Addressing Clause 185 comments against D2.0 for 800GBASE-LR1

(Support contribution for Comment #625)

P802.3dj Plenary Meeting, Madrid, Spain, Jul 2025

Comment #625

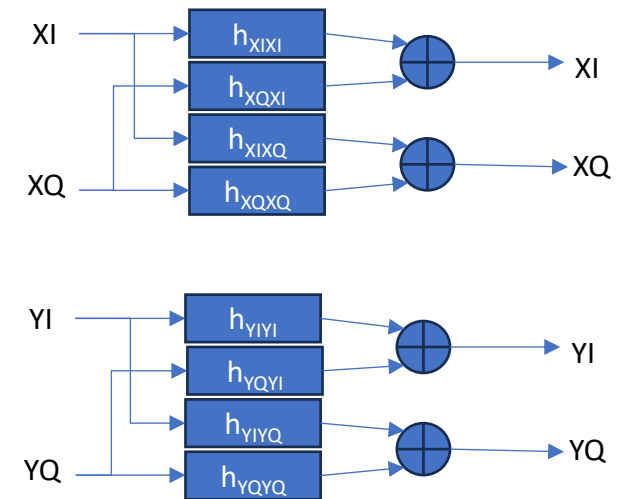
The offline digital signal processing described in this section and Fig 185A-4. is missing a post-equalizer after the "carrier phase recovery" block which is required to allow relaxation of the "IQ Quadrature skew (max)" spec to 0.75ps in Table 185-5. The relaxed skew specification is required to allow design of lower complexity 800GBASE-LR1 modules. Without this block the ETCC calculation will result in a large penalty if the skew gets close to the max allowed value.

Add post-equalizer stage to the digital signal processing. Presentation to be provided.
